Dear Lars,

We are very grateful for your in-depth review of our manuscript and your comments are extremely helpful and no doubt will improve our manuscript.

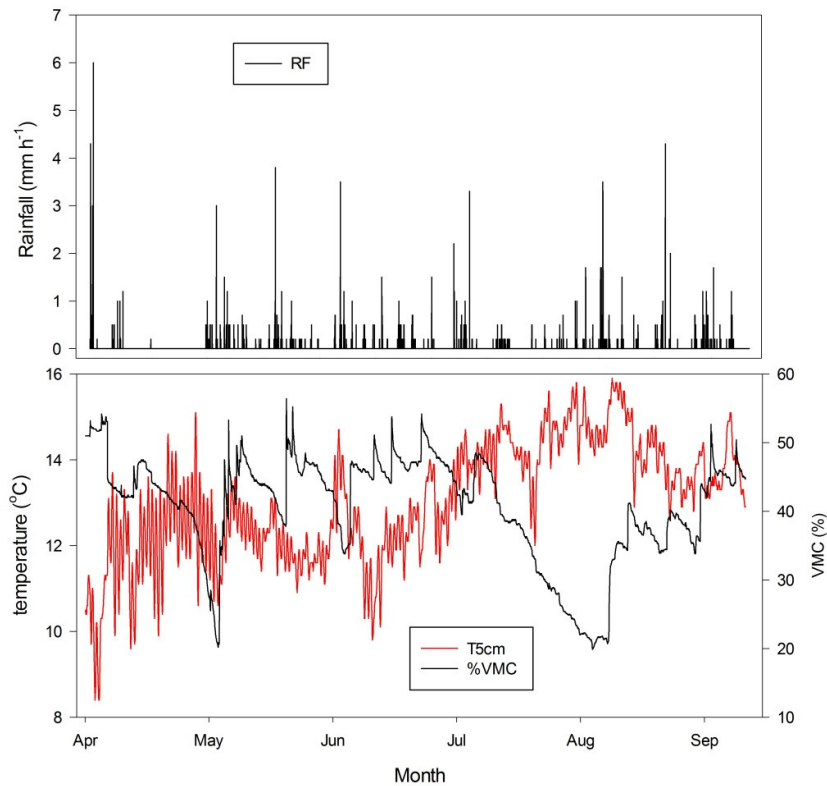
Figure 3: specify what error bars in panel a represent. At what depth were VMC measured and are the low contents in May believed to be real? Maybe you could have included precipitation data to substantiate the dynamics.

Figure 3: error bars in panel (a) were specified in addition to the depth that VMC was measured at. We believe that the low VMC contents measured in May are the response to a very dry spell from mid April/early May (caused by a combination of low RF and increased temperatures). This is perhaps more clearly seen in the figures below, which show hourly RF (mm), and where T5CM and VMC data (recorded at 10 min intervals) are overlain. The low VMC values observed for this period are supported by WT data from the site (not shown), which showed that WT levels in early May were deeper than we were able to detect with our experimental set up. We agree that precipitation data would add useful information to this graph; unfortunately the sensor logging rainfall at our site malfunctioned in late December. We do not feel that it would be useful to provide rainfall data in such an incomplete form for the manuscript but are happy to incorporate it here in our response to your comment.
